*Gold Line*

BUS RAPID TRANSIT PROJECT • ENVIRONMENTAL ASSESSMENT (EA)/  
FINDING OF NO SIGNIFICANT IMPACT (FONSI)

# **ENVIRONMENTAL RE-EVALUATION**

December 2021

**FIGURE 2-3: 5TH STREET BETWEEN WASHINGTON STREET AND ST. PETER STREET – 100% DESIGN**

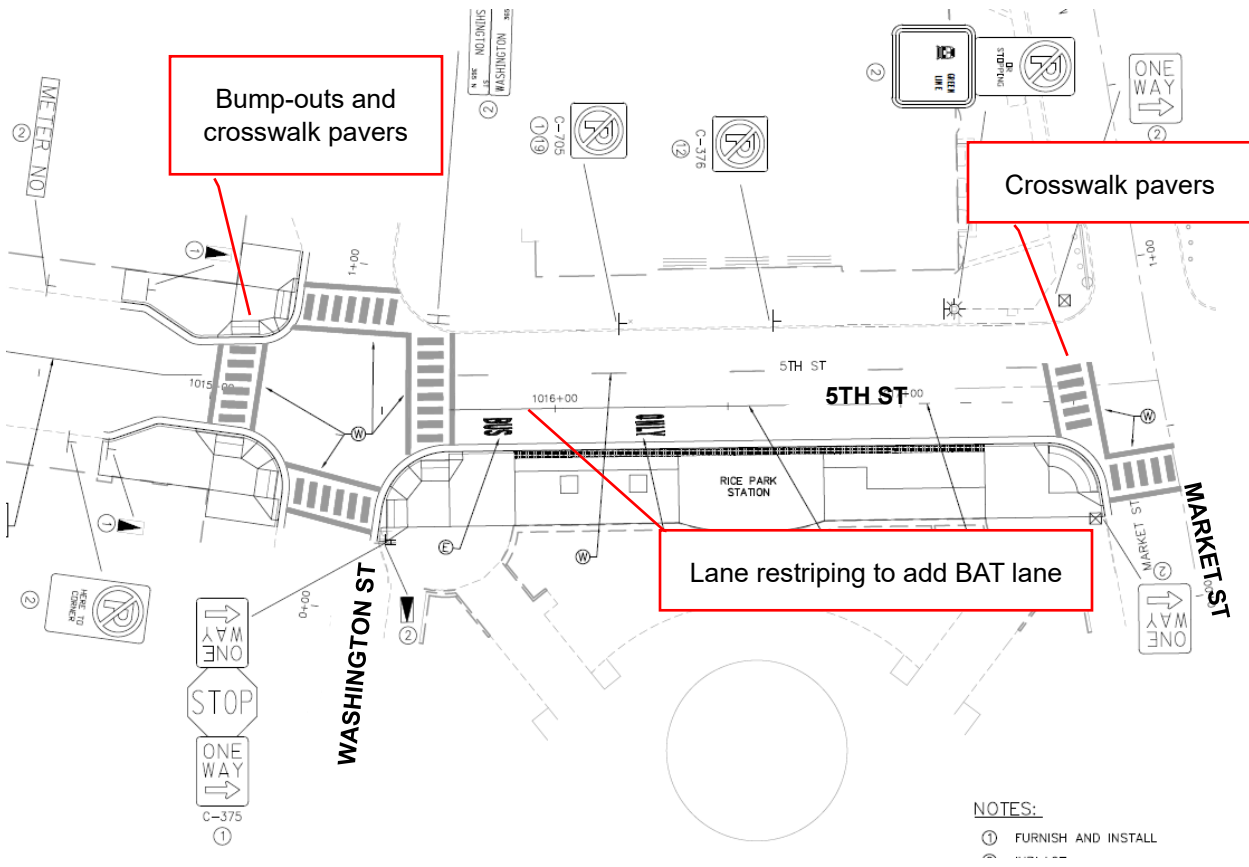
Location	Existing Condition	Improvements defined in EA/FONSI	100 Percent Design Modifications
5th Street between Washington Street and St. Peter Street (Figure 2-3)	Pavers define cross walks at 5th Street/Washington Street and 5th Street/Market Street intersections. 5th Street consists of three through lanes; 5th Street between Market Street and St. Peter Street used to have a former Bus Access Transit (BAT) lane.	No changes at existing curbs or crosswalks. BRT would operate in mixed traffic between Washington Street and St. Peter Street.	In coordination with the City of Saint Paul, the pedestrian experience will be improved along 5th Street. The Project adds bump outs in the southwest and northwest corners of 5th Street/Washington Street intersection. Crosswalk pavers in 5th Street/Washington Street intersection are replaced, as are west and south pavers in the 5th Street/Market Street intersection.  The Project will restripe 5th Street for two through lanes and establish a dedicated Bus Access Transit (BAT) lane on 5th Street between Washington Street and St. Peter Street.

FIGURE 2-4: 5TH STREET BETWEEN CEDAR STREET AND ROBERT STREET – 100% DESIGN

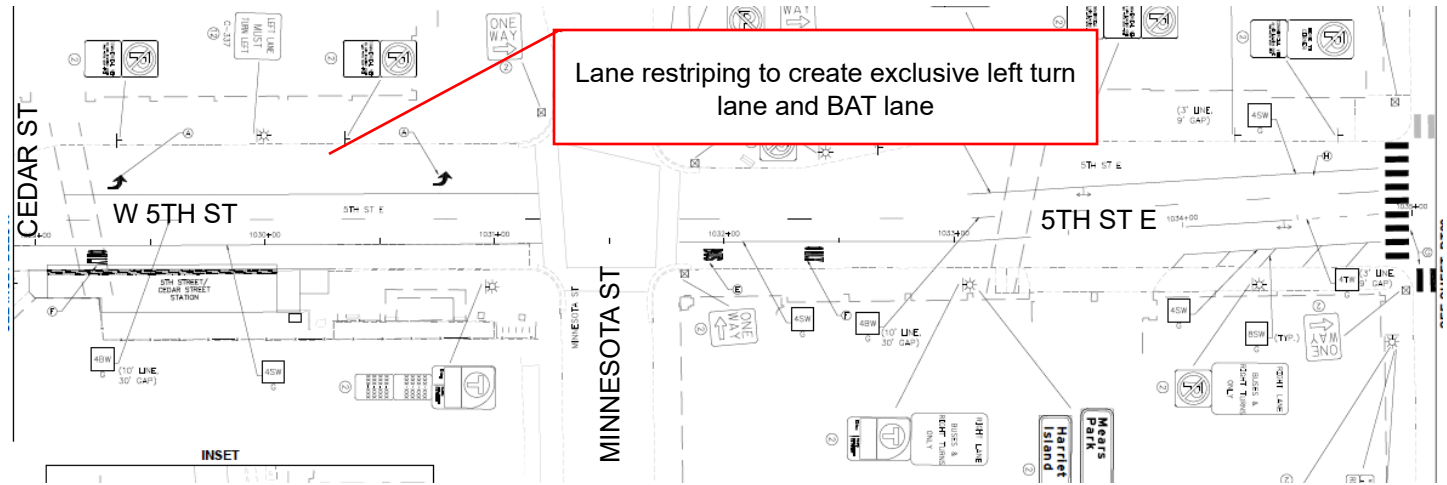
5th Street between Cedar Street and Robert Street (Figure 2-4)	5th Street is striped as three through lanes, with an exclusive left and shared left/thru lane onto Minnesota Street. The existing exclusive left turn lane is frequently used for parking, making the shared left/thru lane an exclusive turn lane.	No changes to lane definition for turning or through travel lanes, except BRT would operate in dedicated bus lane.	City of Saint Paul is completing the following work as part of a larger improvement project on 5th Street: restriping lanes to provide one left turn lane, two through lanes and one BAT lane. The former exclusive left turn lane will become used for parking and loading.
6th Street/Washington Street intersection (Figure 2-5)	There are no Reflecting Flashing Beacons (RRFB) present in the intersection.	Project would include sidewalk bump-outs at Hamm Plaza.	In coordination with City of Saint Paul, pedestrian signals will be added, which requires installation of mast head and signal poles (Figure 2-6).

FIGURE 2-7: 4TH STREET AND SIBLEY STREET SIGNAL CABINET LOCATION – EXISTING CONDITIONS

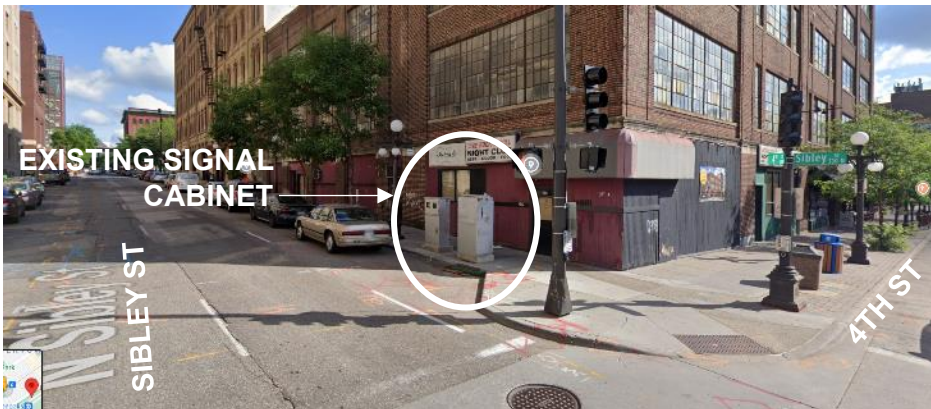
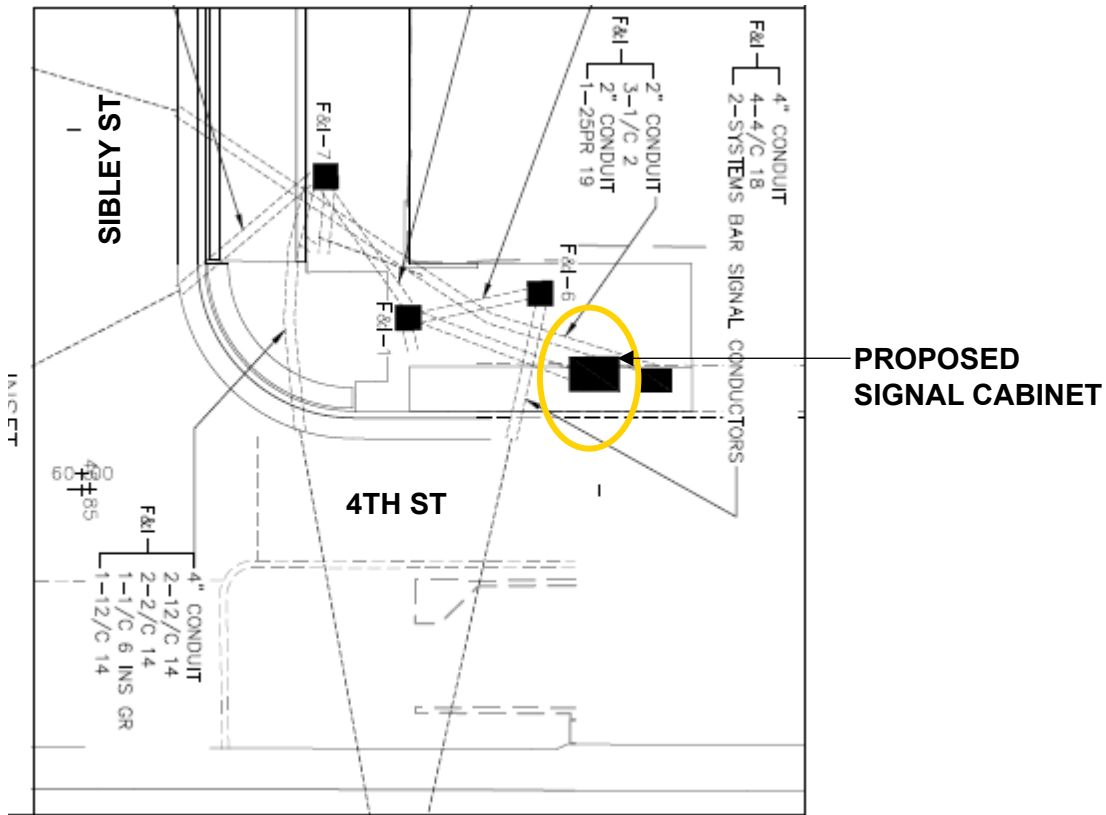
4th Street and Sibley Street (Figure 2-7)	Signal cabinet on Sibley Street.	No changes identified; Signal cabinet anticipated to remain on Sibley Street.	In coordination with the City of Saint Paul, signal cabinet will be moved to 4th Street (Figure 2-8). Moving signal box from behind the bus platform because it would be inaccessible for future maintenance. Fiber will be within existing conduit.

**FIGURE 2-9: 3RD STREET INTERSECTION WITH MOUNDS BOULEVARD – 100% DESIGN**

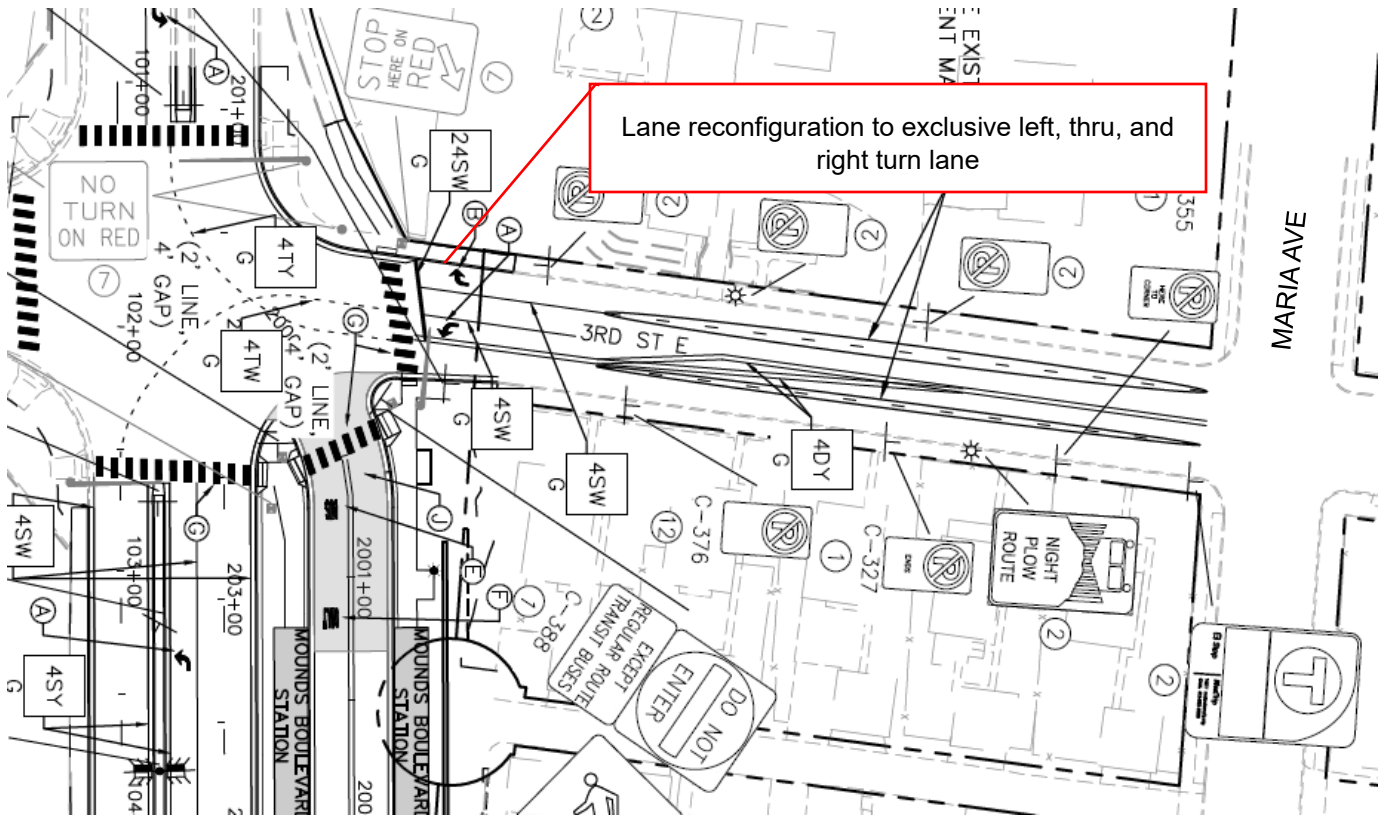
Location	Existing Condition	Improvements defined in EA/FONSI	100 Percent Design Modifications
3rd Street intersection with Mounds Boulevard (Figure 2-9)	3rd Street as it approaches Mounds Boulevard consists of two northbound and two southbound travel lanes. On-street parking on the south side of 3rd Street accommodates approximately 16 parking places during off-peak hours.	No changes to 3rd Street approach.	In coordination with City of Saint Paul, the 3rd Street approach to the intersection will be restriped with exclusive southbound left, through, and right turn lanes and one northbound through lane. Approximately 100 feet east of the intersection, 3rd Street will then be restriped to two lanes with a median barrier. Restriping will remove about 200 feet of parking lane on the south side of 3rd Street, or up to approximately ten parking spaces.

**FIGURE 2-10: DOWNTOWN SAINT PAUL FIBER INSTALLATION – 15% DESIGN AND 100% DESIGN**

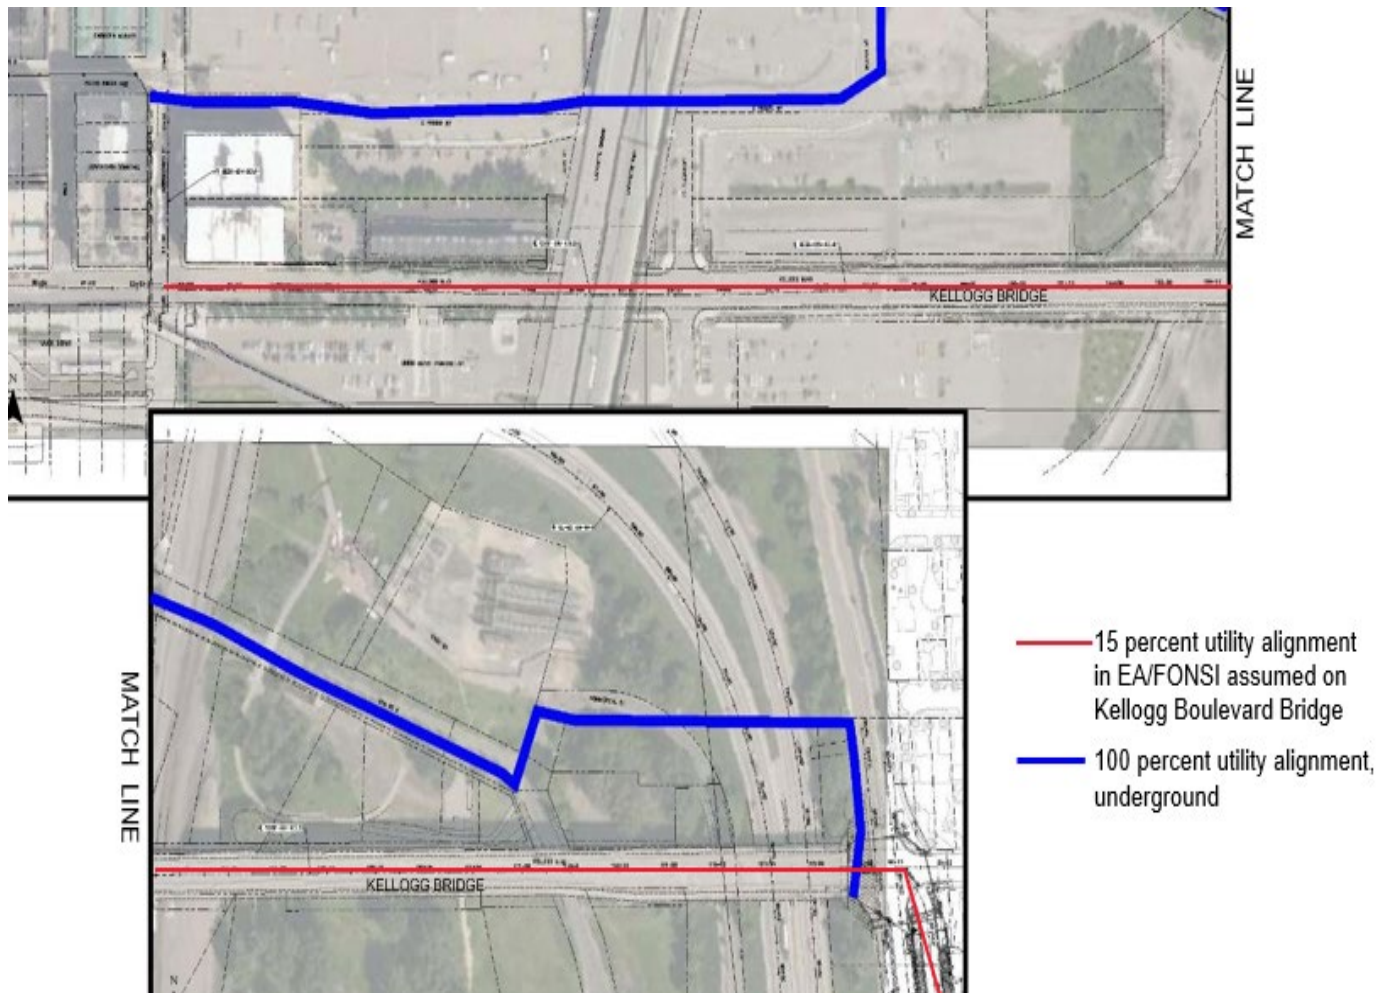
The EA/FONSI identified potential utility impacts at the 15 percent concept design. Ongoing design maintained the fiber installation attached underneath the Kellogg Boulevard bridge. The bridge will be reconstructed independently by the City of Saint Paul and is anticipated to be complete prior to Project opening. The 100 percent design relocated the fiber north of the bridge, underground within an existing utility corridor, to avoid construction phase coordination efforts and potential service disruption during future bridge maintenance activities. The underground fiber installation will cross under I-94 and the BNSF railroad corridor. The fiber installation is outside the 15 percent LOD. Figure 2-10 shows the 100 percent utility location.

**FIGURE 2-13: MAPLE STREET PEDESTRIAN BRIDGE PLAN VIEW – 100% DESIGN**

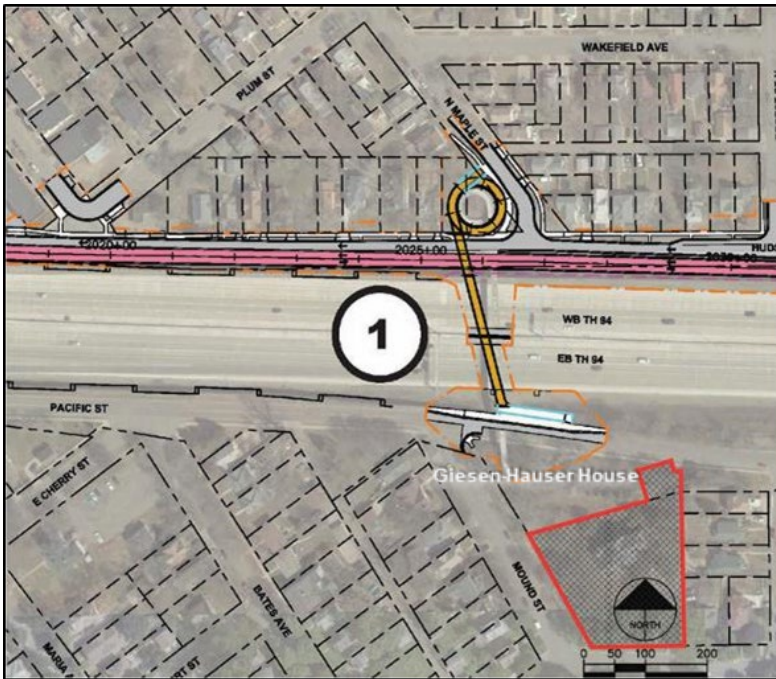
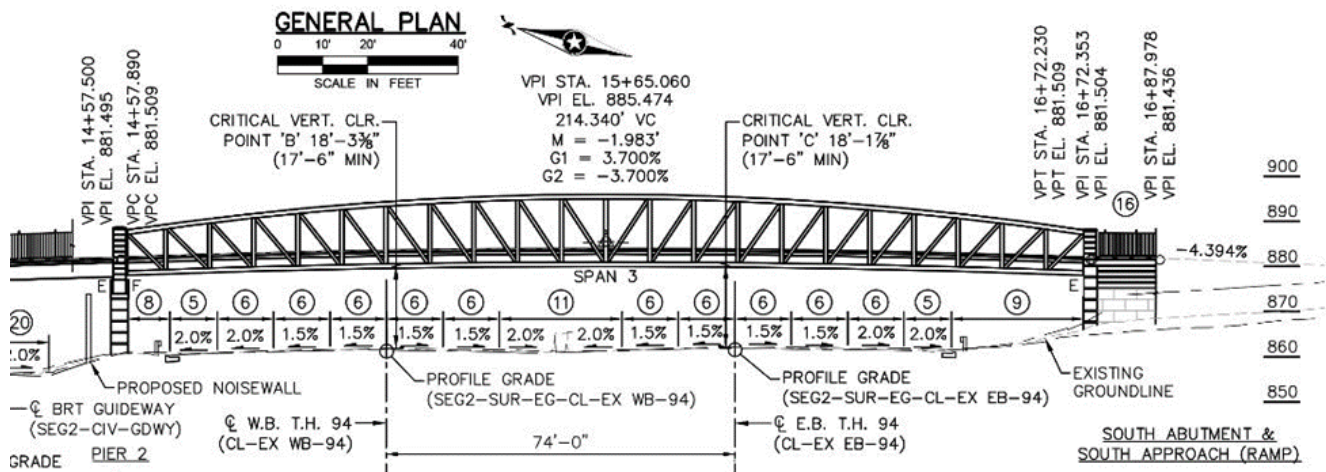
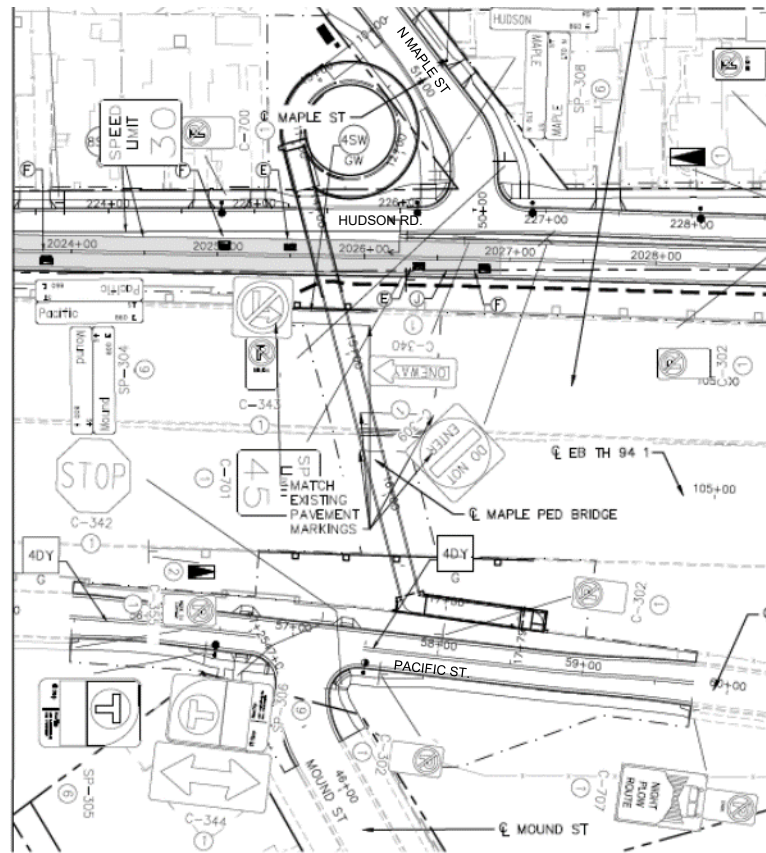
The Maple Street pedestrian bridge alignment was altered during the 30 percent re-evaluation (see Figure 2-11) and the bridge type changed to a truss bridge at the 90 percent re-evaluation (see Figure 2-12). The southern bridge touchdown point in the 100 percent design requires narrowing Pacific Street and prohibiting parking on the south side of the street in the vicinity of the touchdown point. The 100 percent design changes are within the 90 percent LOD re-evaluated previously. Figure 2-13 shows the 100 percent design.

FIGURE 2-14: PARKING MODIFICATIONS ON HAZEL STREET – 100% DESIGN

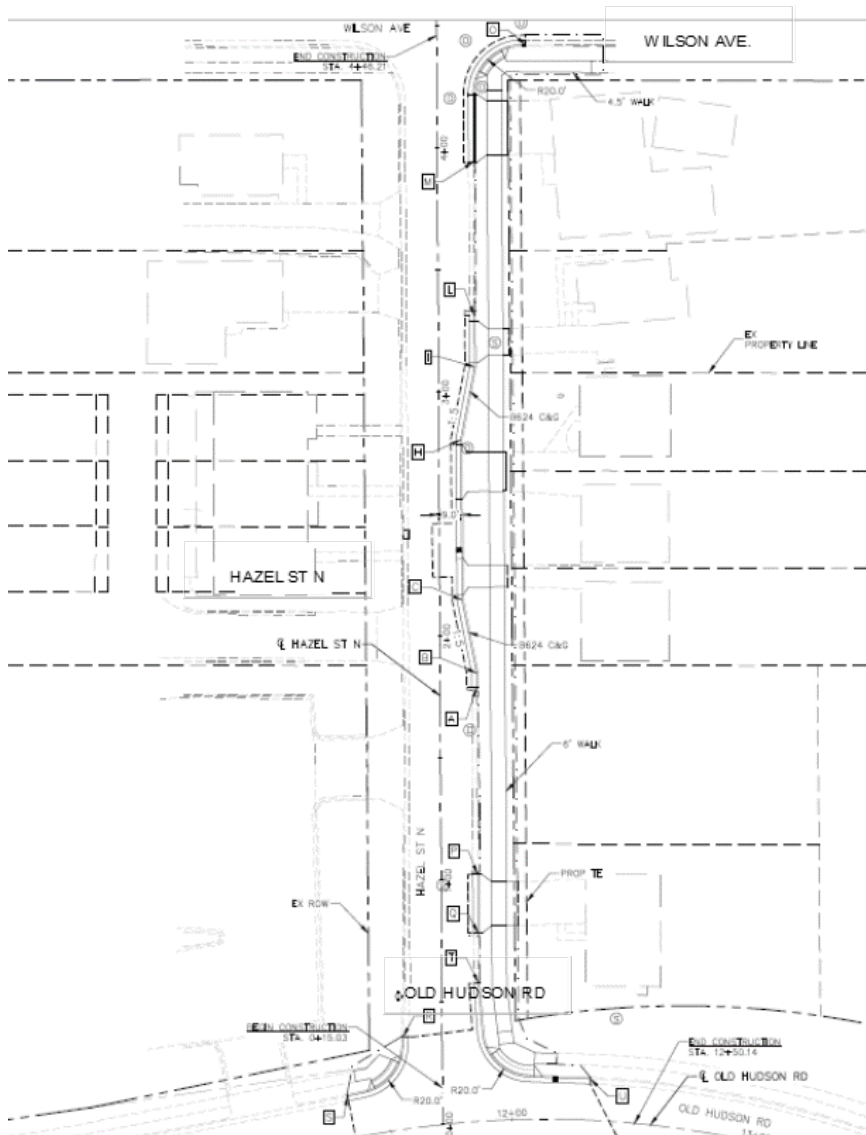
The EA/FONSI did not identify parking impacts on Hazel Street. The 100 percent design currently identifies the need for grading to match existing driveway profiles on the east side of Hazel Street between Old Hudson Road and Wilson Avenue. The additional grading bumps out curbs and driveways for a distance of approximately 125 feet, which removes on-street parking. The modifications are within the 15 percent LOD. Figure 2-14 shows 100 percent design. Table 2-5 summarizes changes in impacts to resources affected by the design change since evaluation the EA/FONSI.

FIGURE 2-15: 15% - NOISE BARRIER F

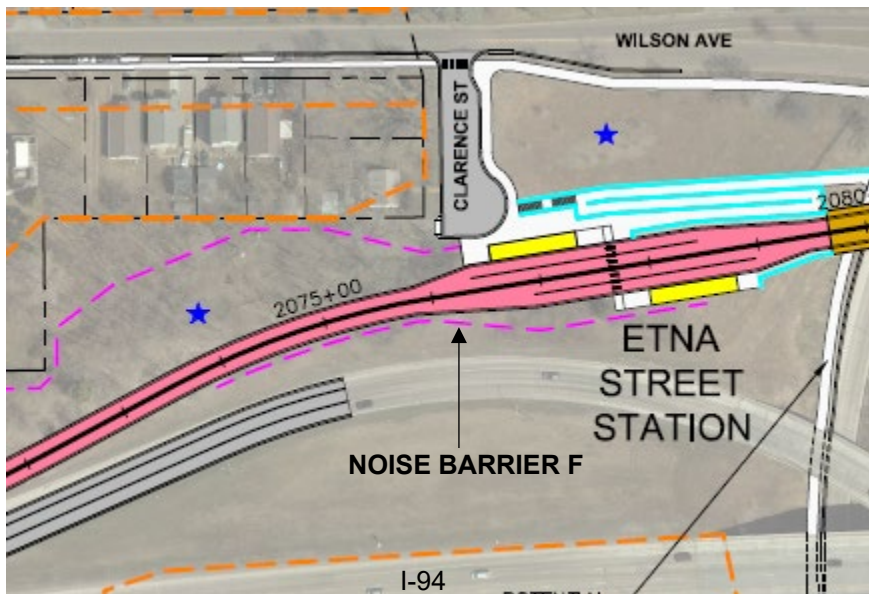
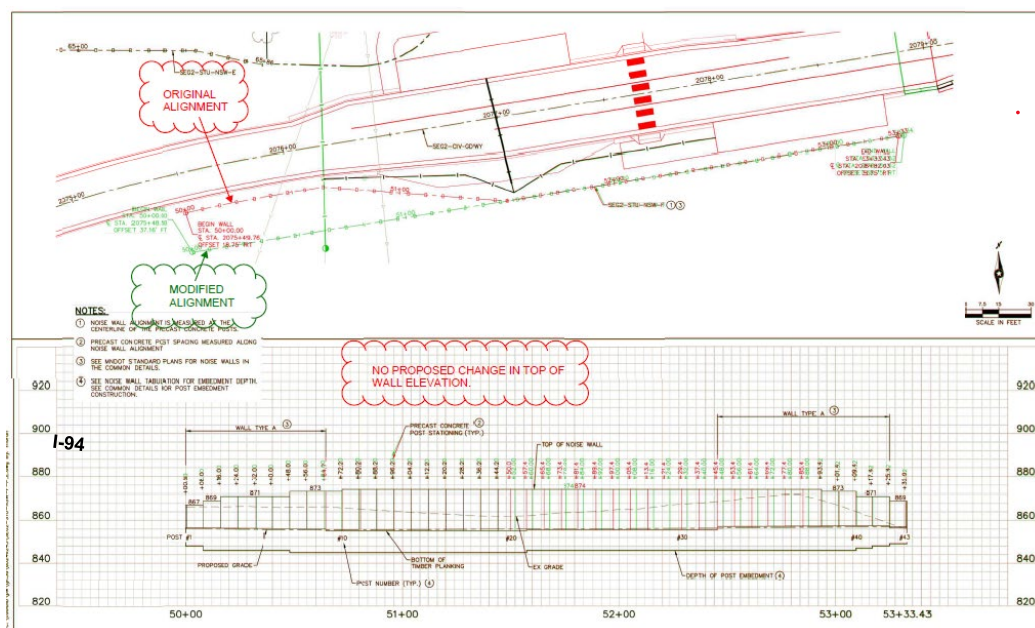
The EA/FONSI identified existing noise barriers to be relocated and replaced, including Noise Barrier F at the Etna Street station (see Figure 2-15). The 100 percent design change improves the sightlines for the BRT guideway by shifting the west end of Noise Barrier F about 37 feet south of the location shown in the EA/FONSI. The 100 percent design change is maintained within the 15 percent LOD. Figure 2-16 shows the 100 percent design. Table 2-6 summarizes changes in impacts to resources affected by the design change since the EA/FONSI.
